NOTICE TO ALL FIRMS

- From: Sam Li Interim Director of Procurement Services
- Re: Addendum Number 1 IFB # C1605 – Men's Locker Room – Shower and Restroom Upgrades

227 WEST 27TH STREET NEW YORK, NY 10001 INTERIOR RENOVATION **ISSUE FOR BID ADDENDUM**

DEMOLITION PLAN Scale: 1/2"=1'-0"

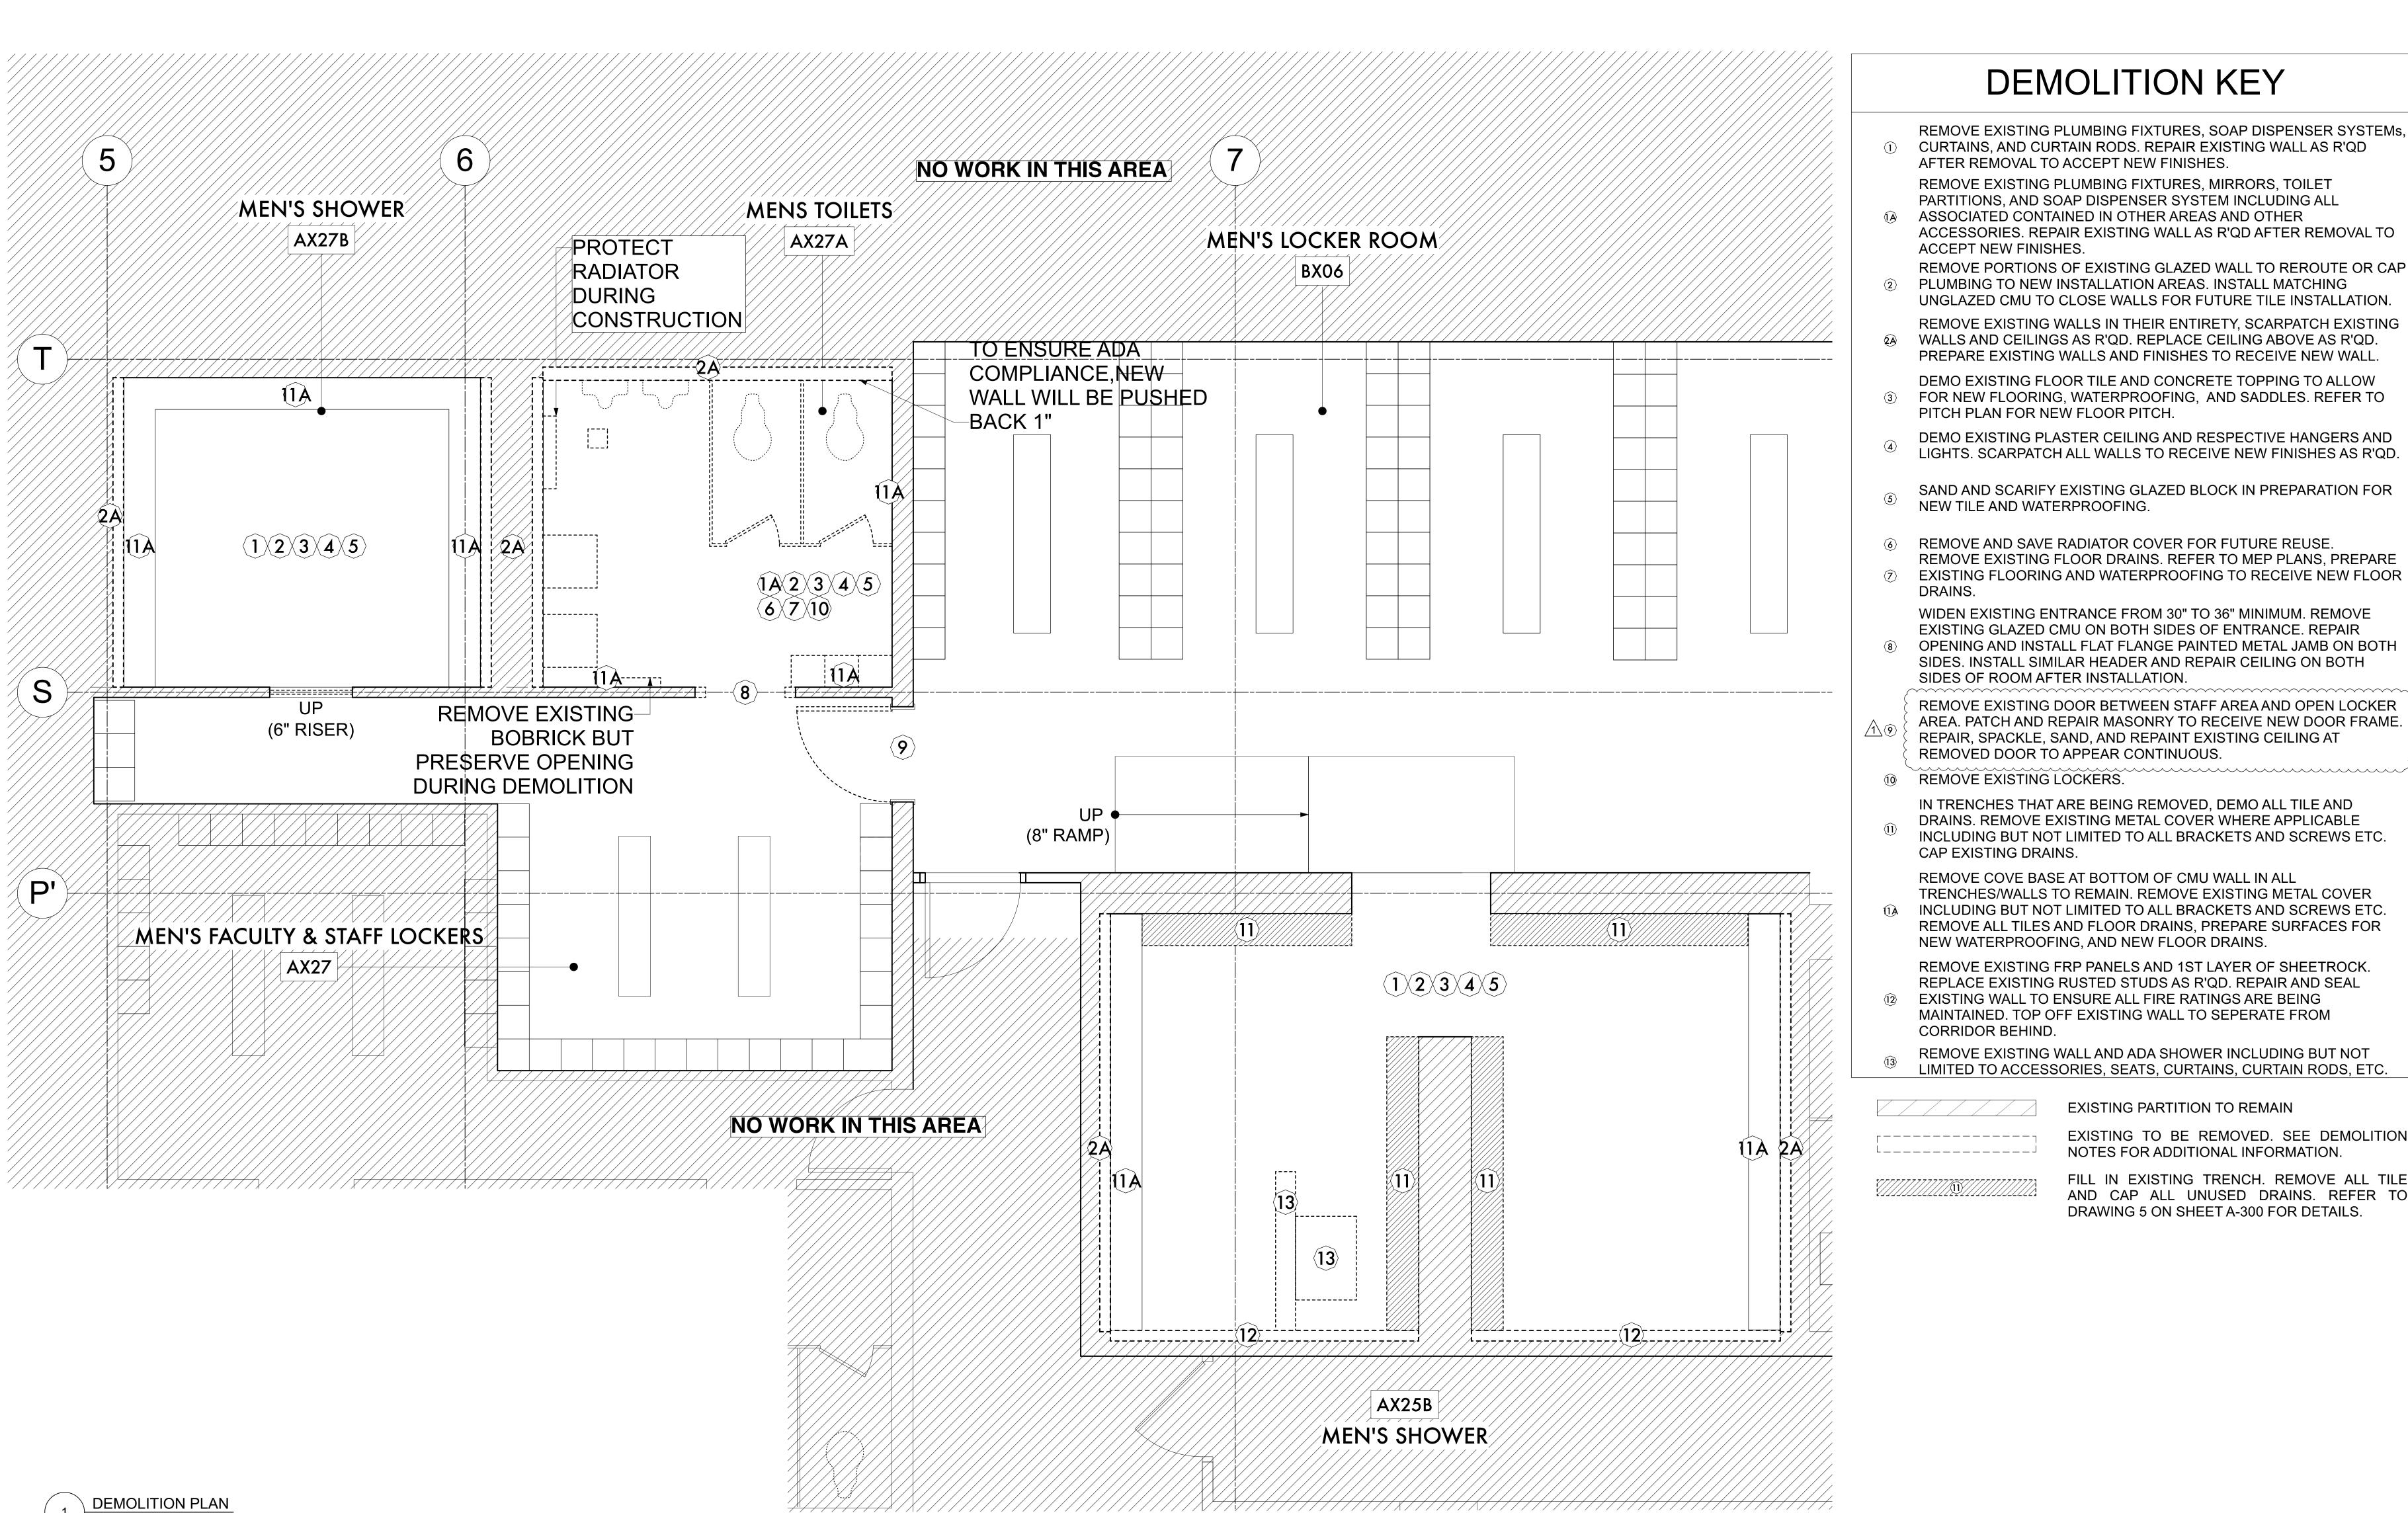
DM-100 – Demolition Plan

Demolition Key

-Note 9 has been clarified. The door jamb is not to remain, it will be removed. Only the masonry around it will be repaired in preparation for new frame.

Drawing Title: MEN'S SHOWERS FINISH PLAN
	Drawing No.: A-102.00
	Project No.: Date: 2214-01 11/1/23

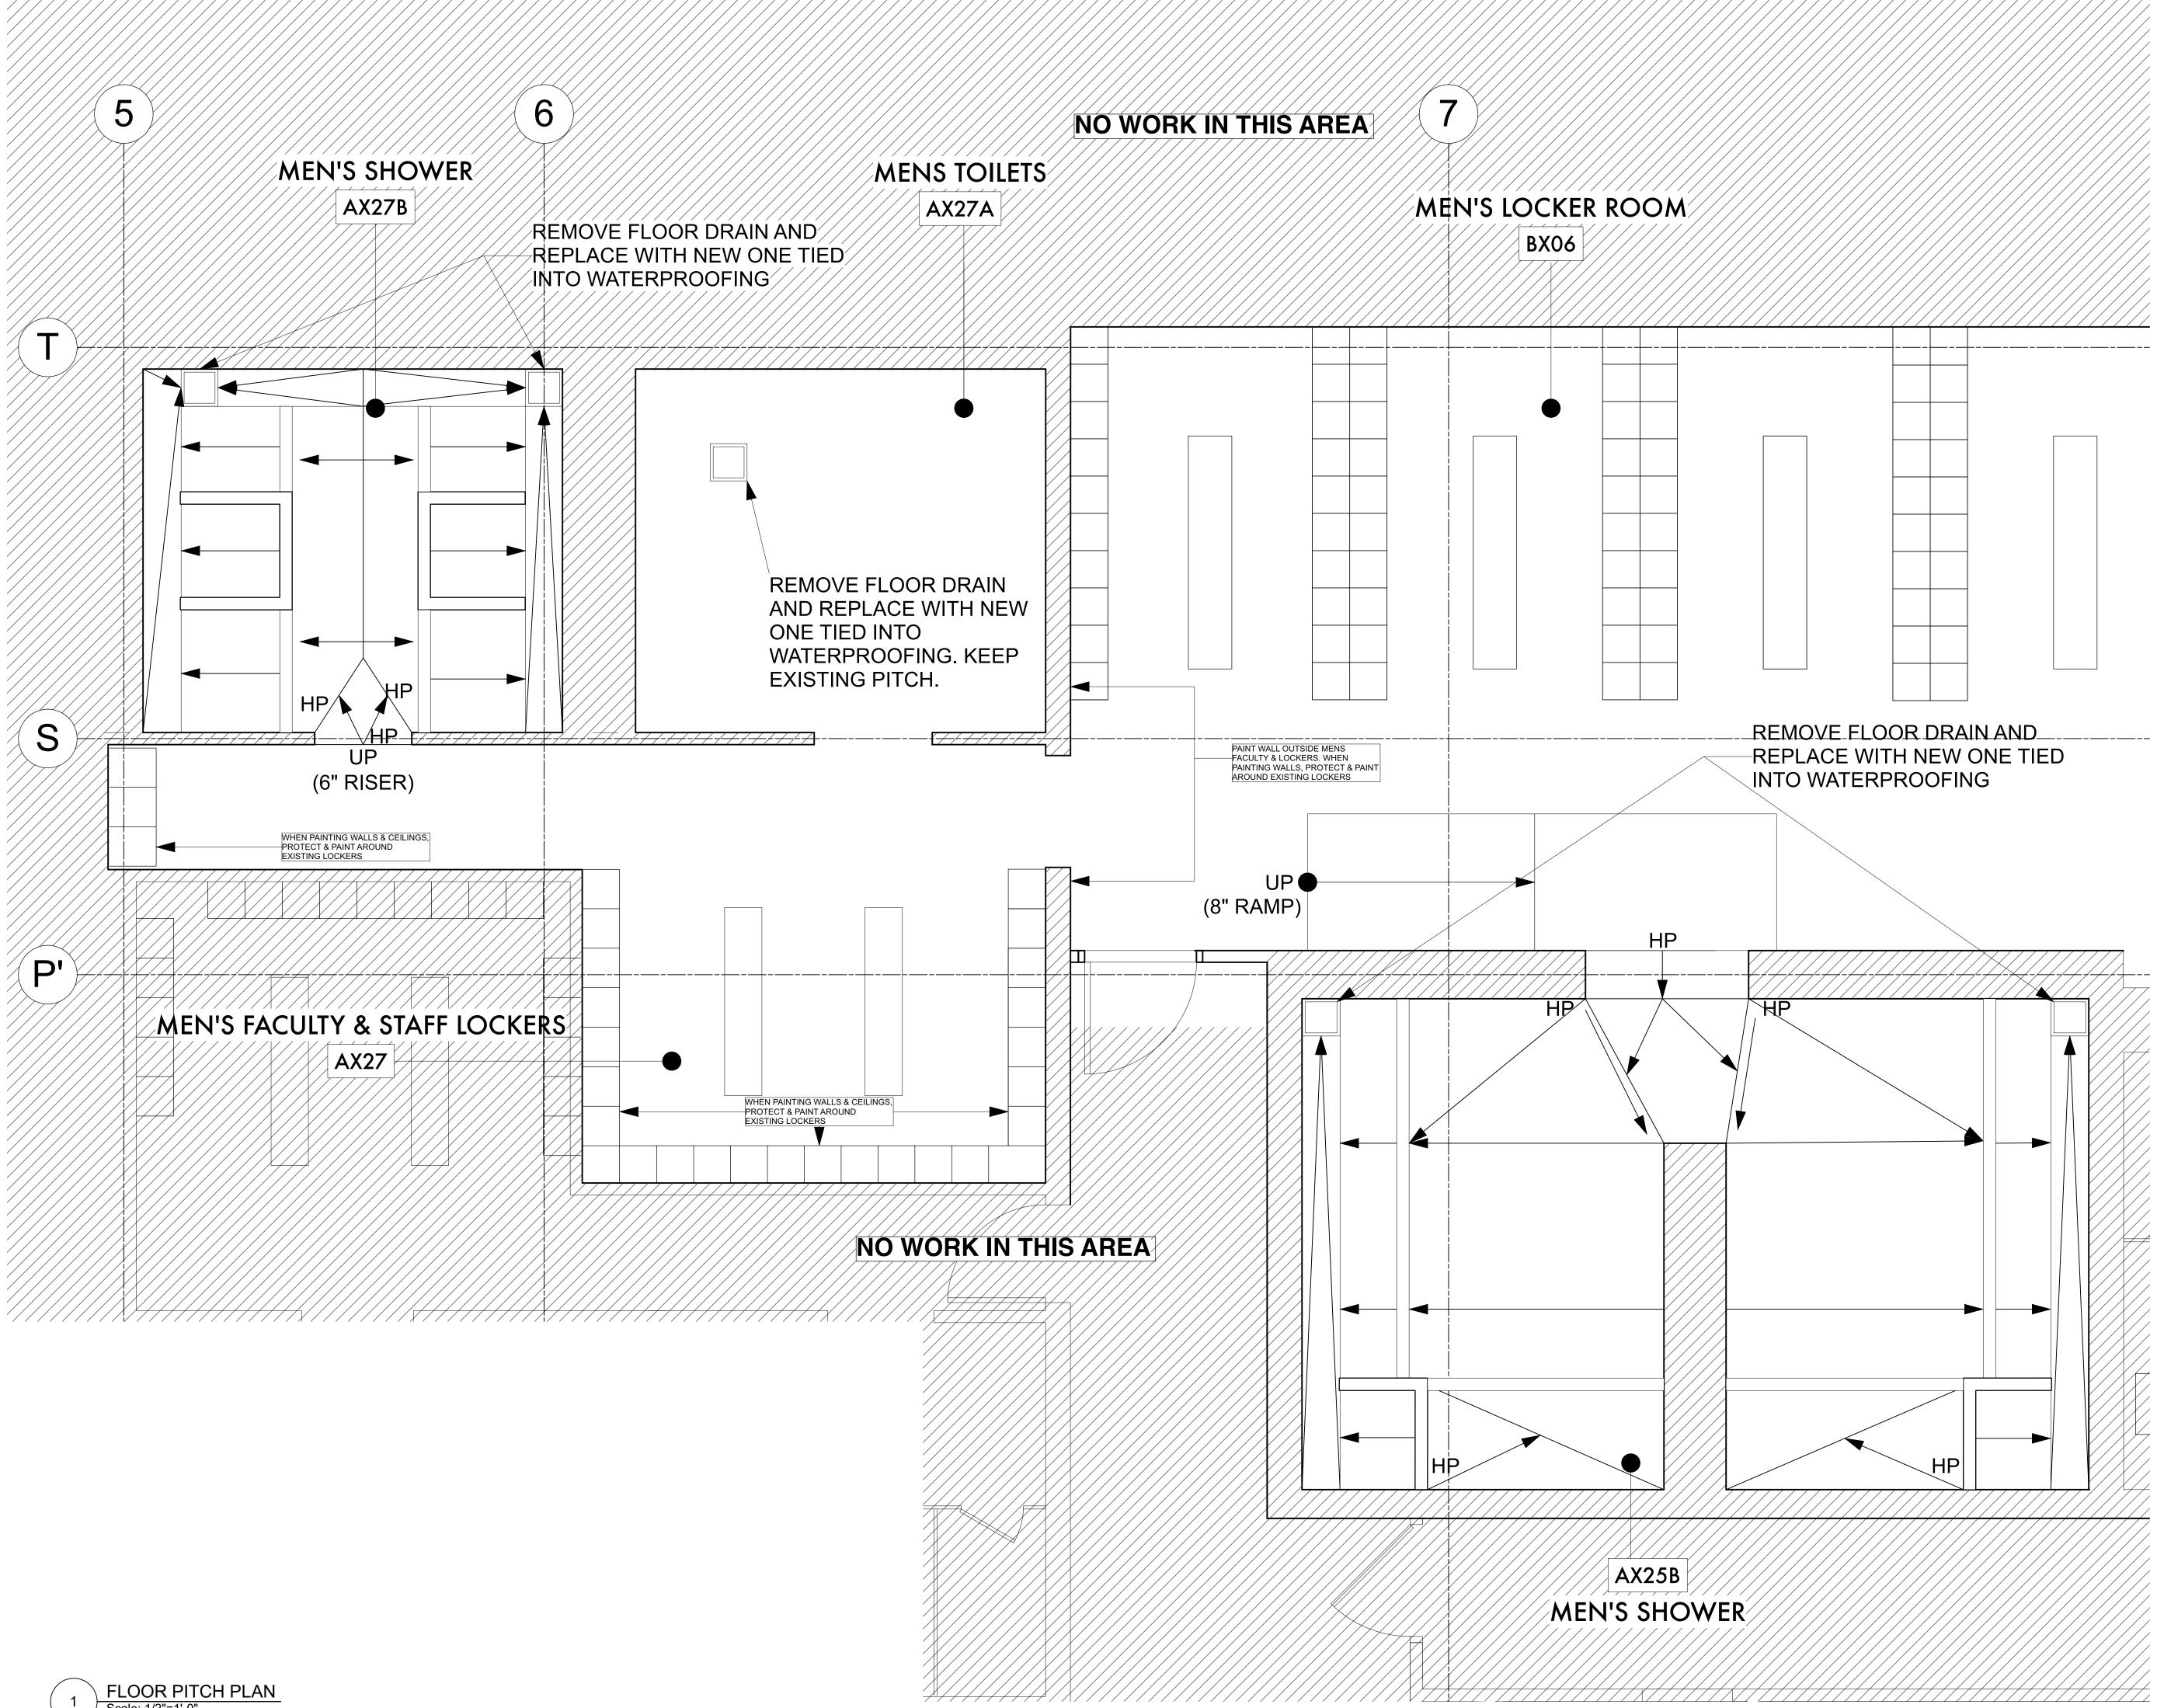
A-102 – Finish Plan

Finish Key

-Key has been updated to reflect ceiling construction. All ceilings are now WT-01, WT-02, and WT-03.

DOB#: M00871728-S RELATED PL FILING DOB#: M00871728-	
KEY PLAN:	
WEST COURTYARD EAST COURTYARD WEST 28TH STREET	
Image: bit of the sector of the s	
Revisions Image: A state of the	
Sign and Seal:	
Drawing Title: MENS FACULTY SHOWER AX-27B ELEVATIONS	
Drawing No :	
A-202.00

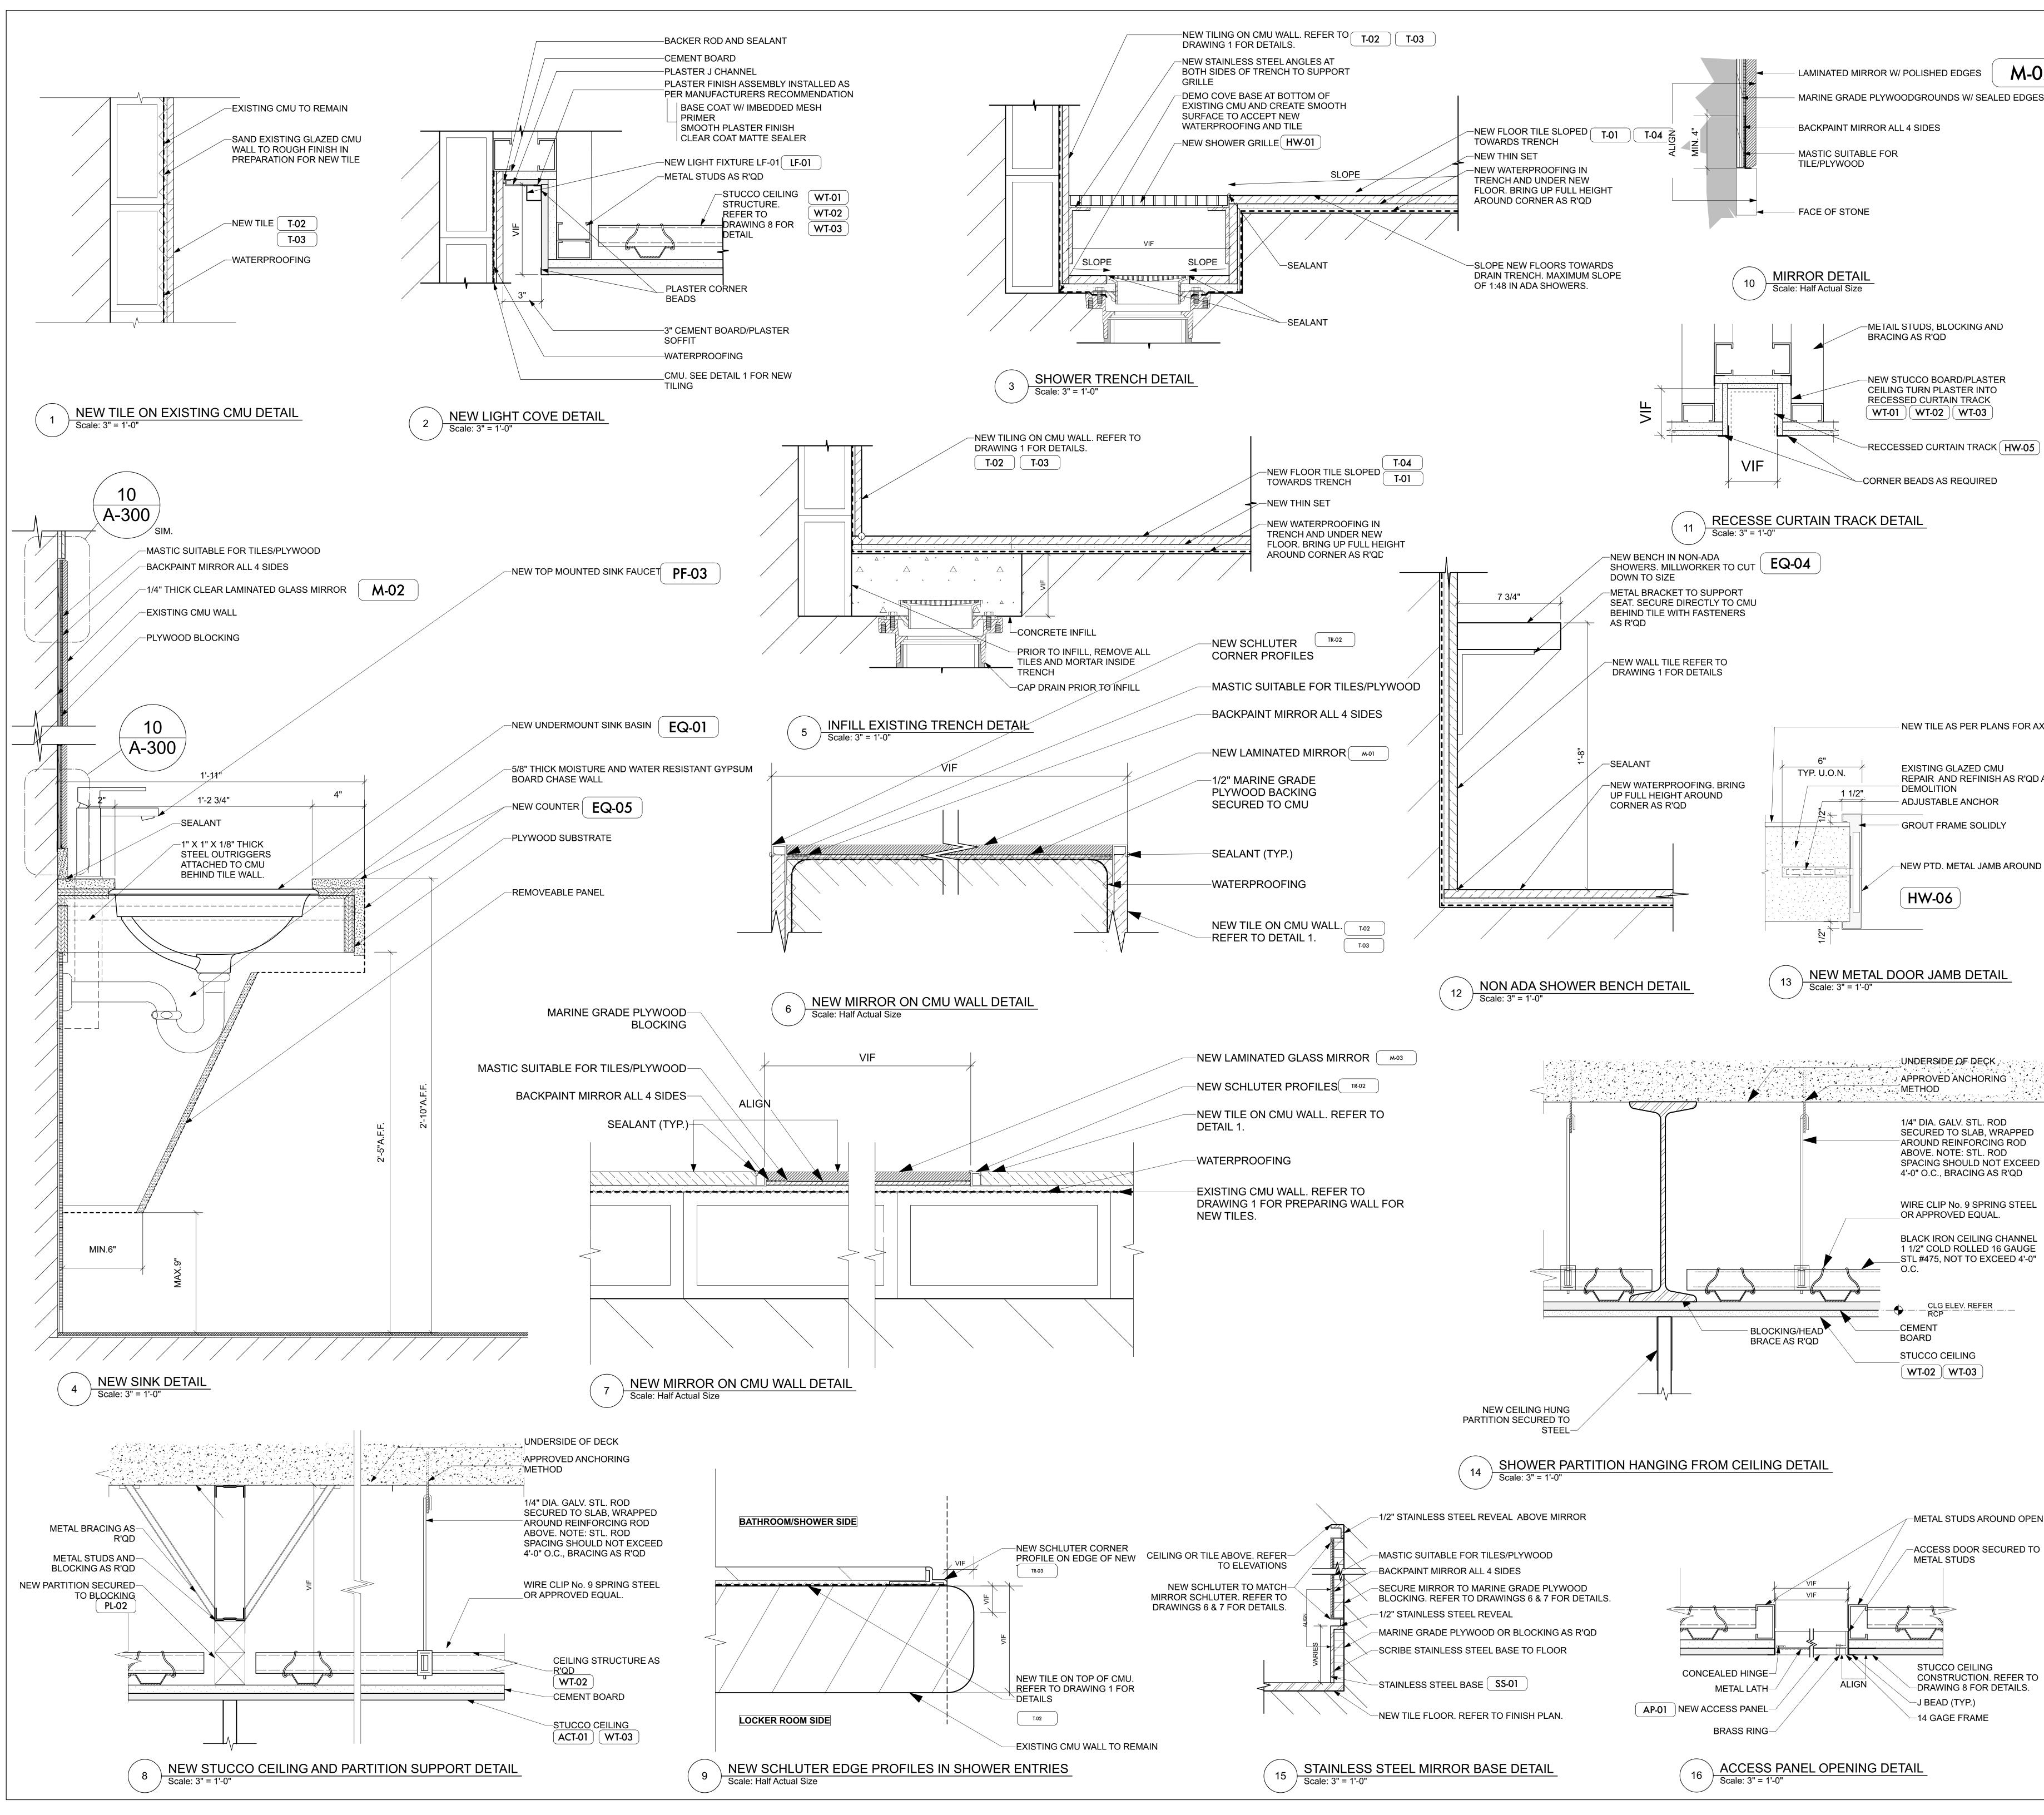
A-200 –Interior Elevations

General

-All decals have been tagged with DM-01 across all interior elevation sheets.
